11675  
Industrial

SITE PLAN  
 SCALE 1"=40'

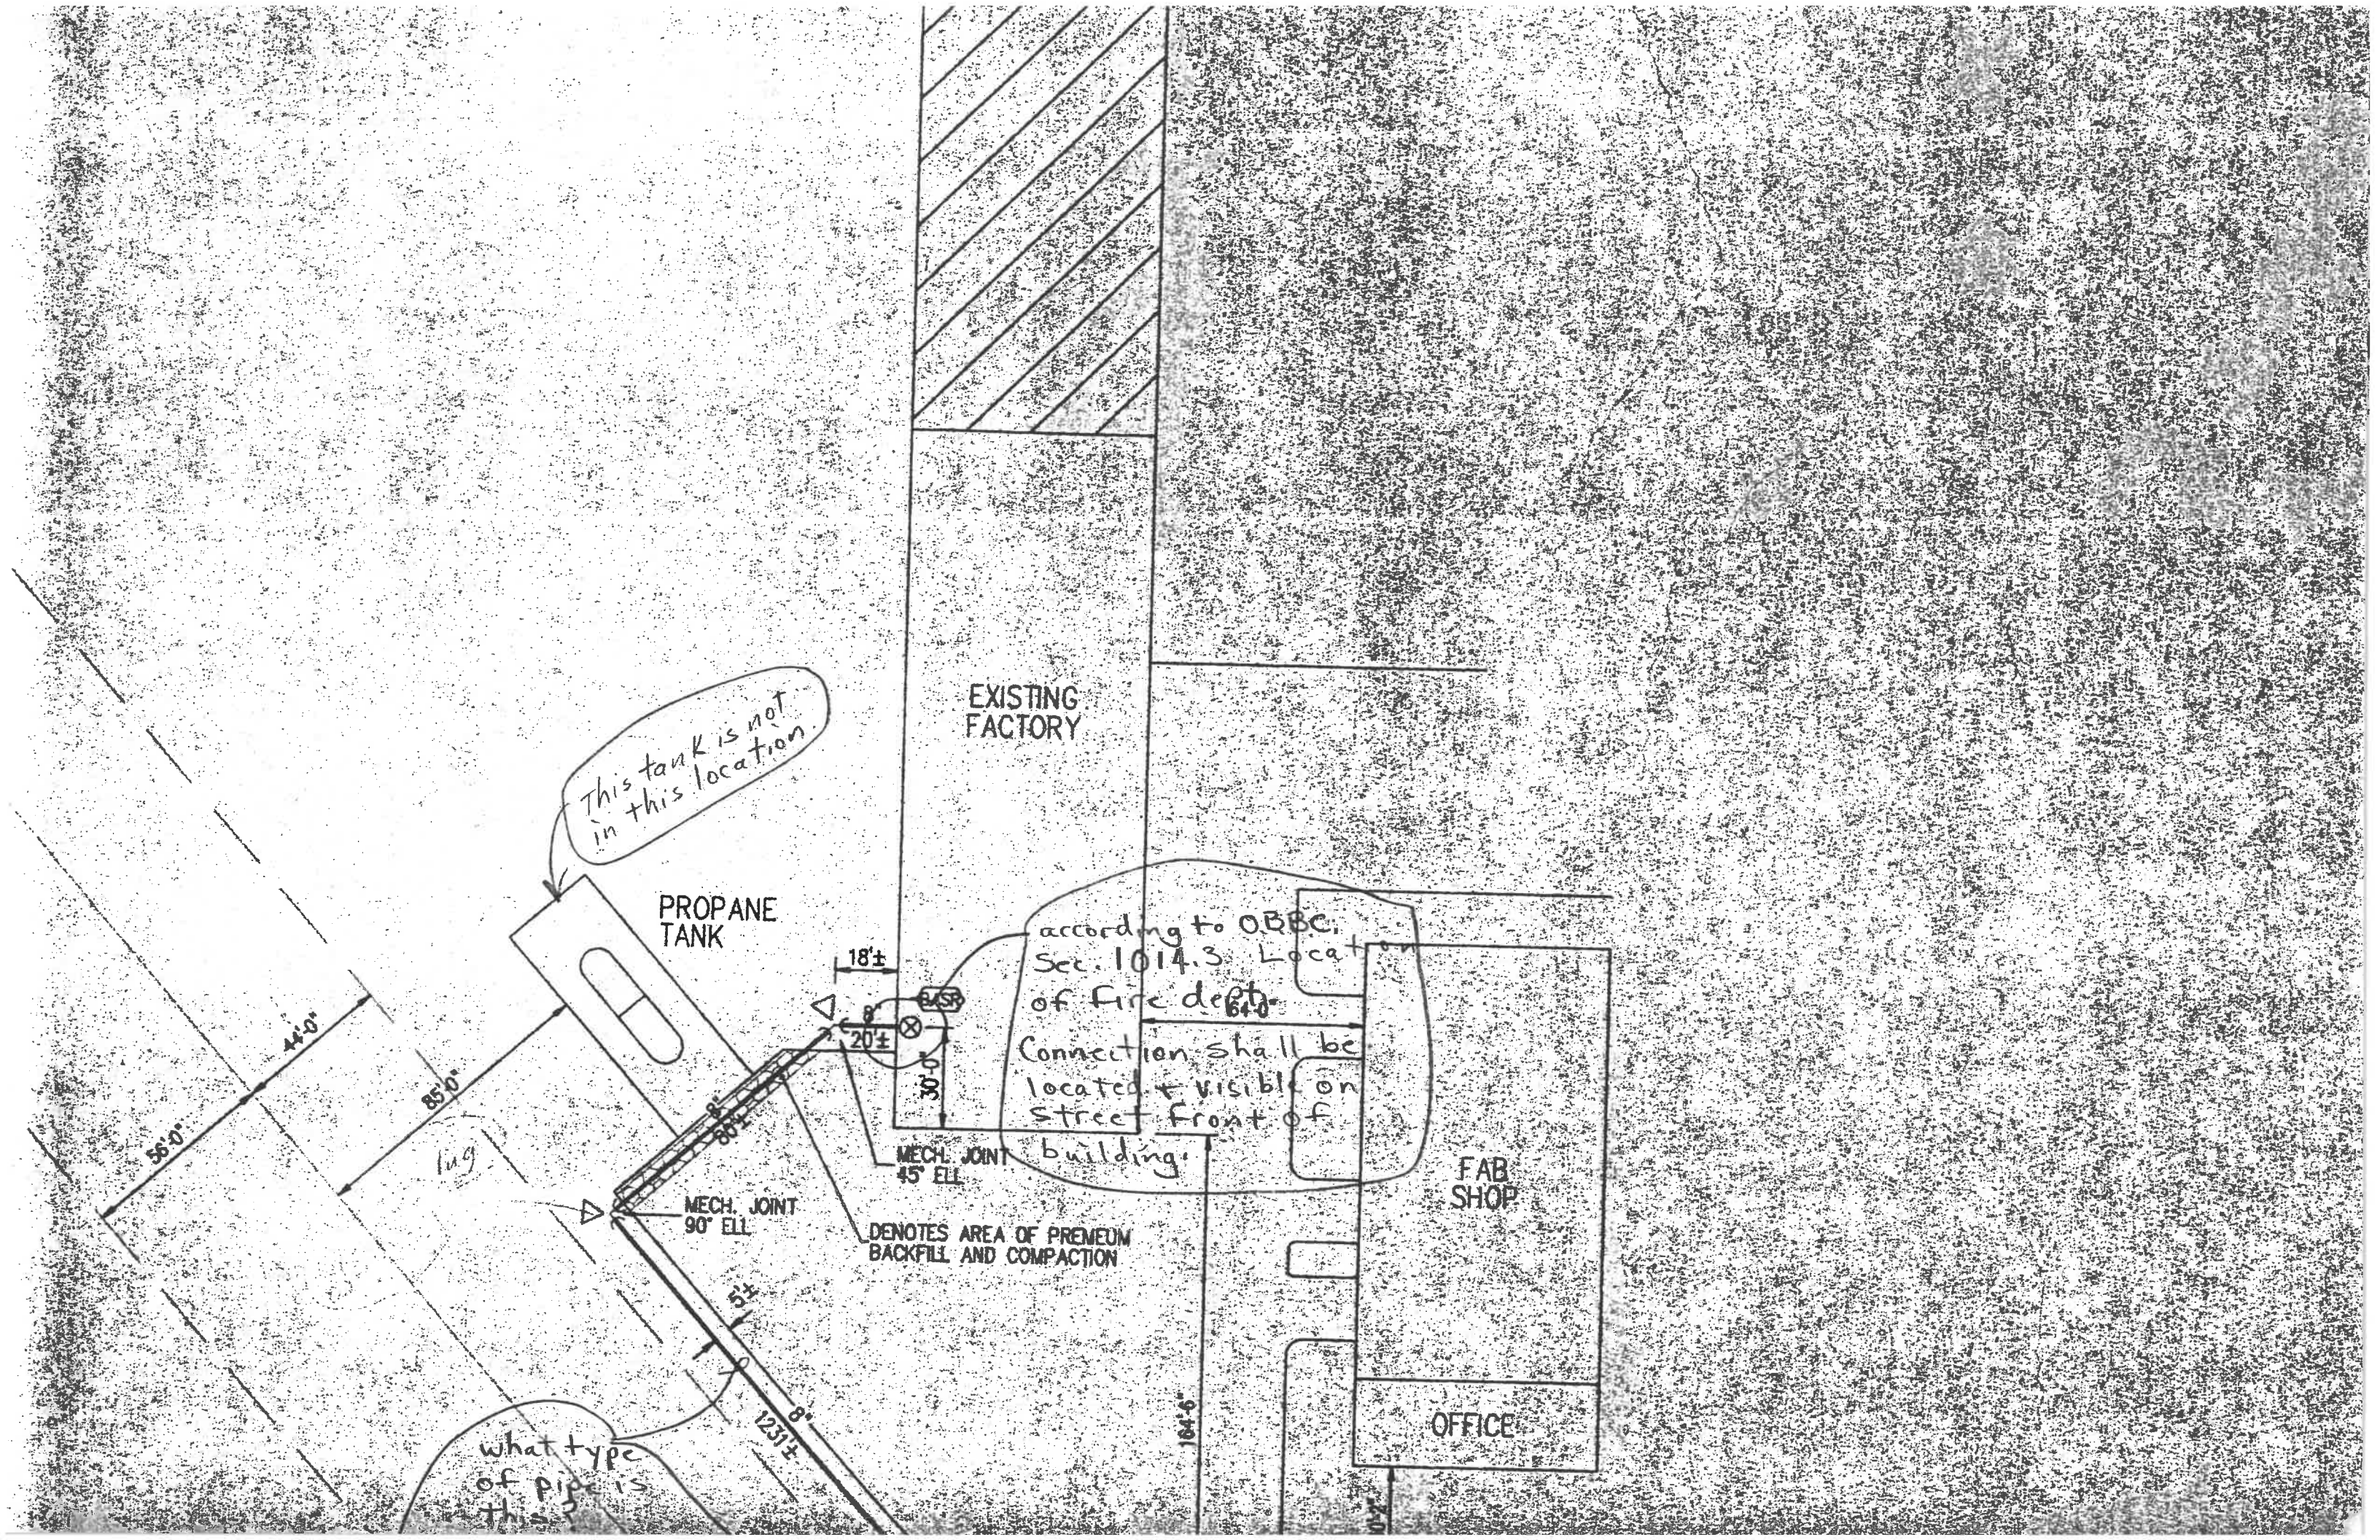
This tank is not in this location.

according to OBBC, Sec. 1014.3 Location of fire dept. Connection shall be located & visible on street front of building.

what type of pipe is this?

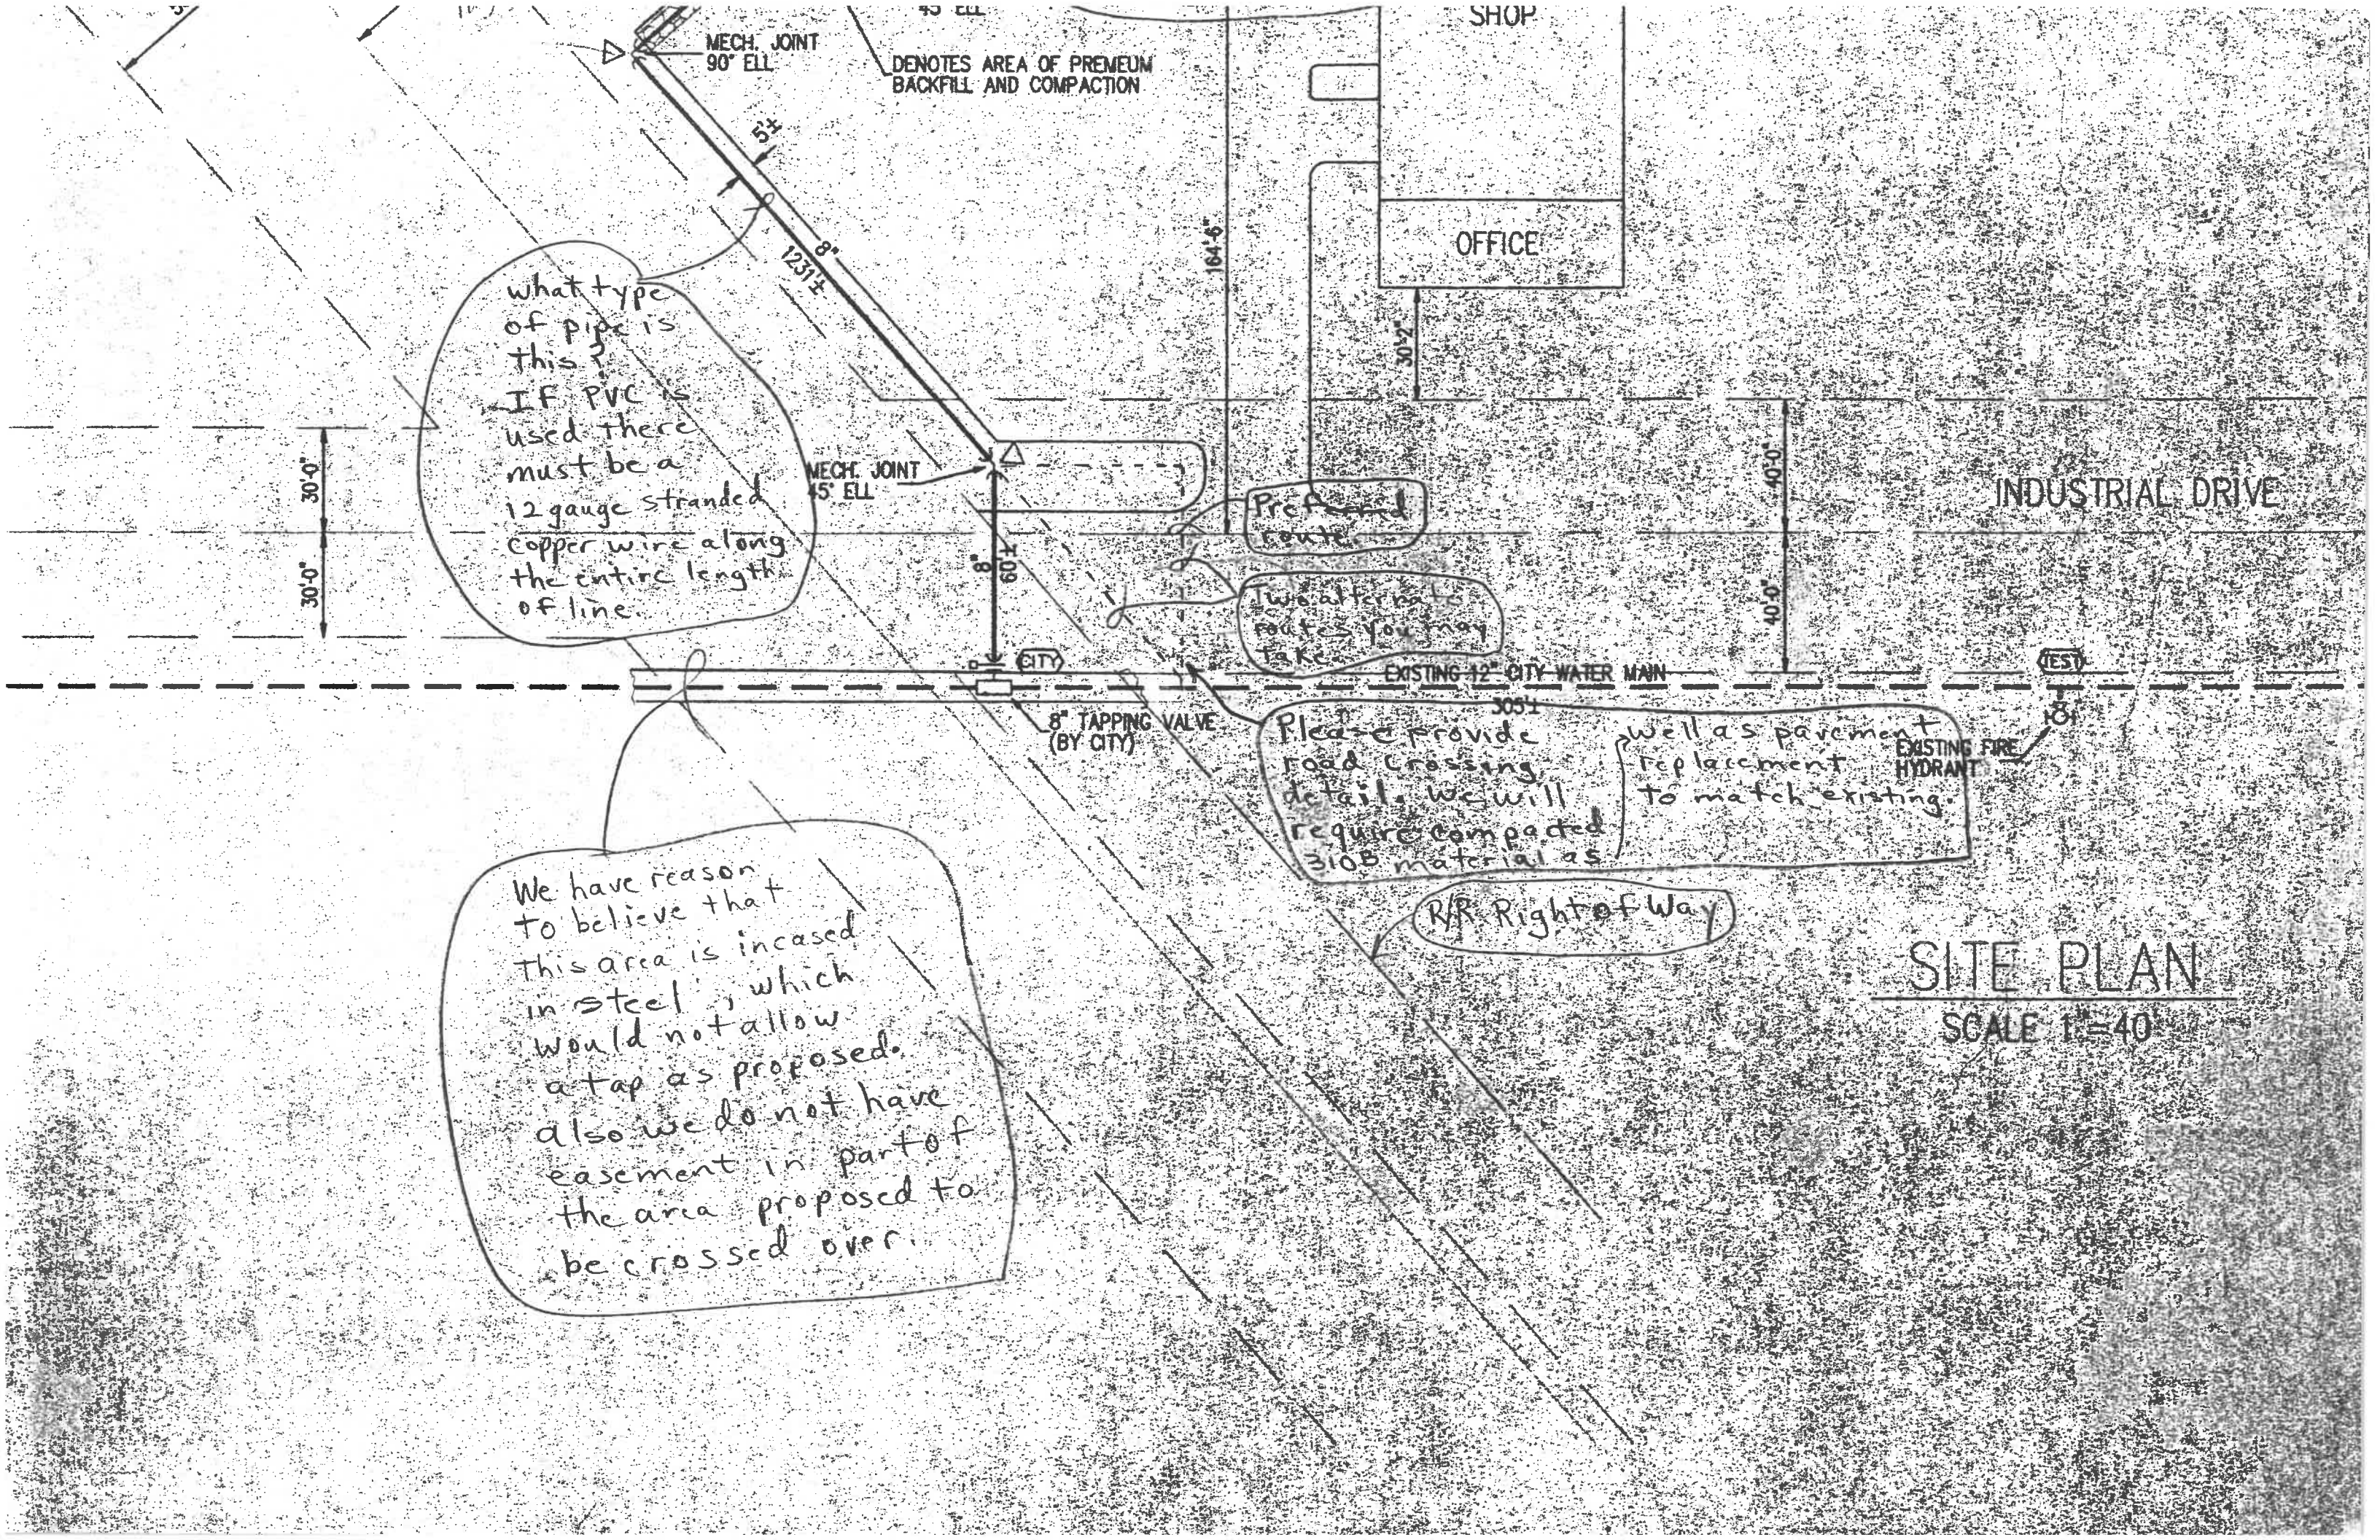
what type of pipe is this?  
 IF PVC is used there must be a 12 gauge stranded copper wire along the entire length of line.

We have reason to believe that this area is incased in steel, which would not allow a tap as proposed. also we do not have easement in part of the area proposed to be crossed over.

Two alternate routes you may take

Please provide road crossing details. We will require compacted 310B material as well as pavement replacement to match existing.
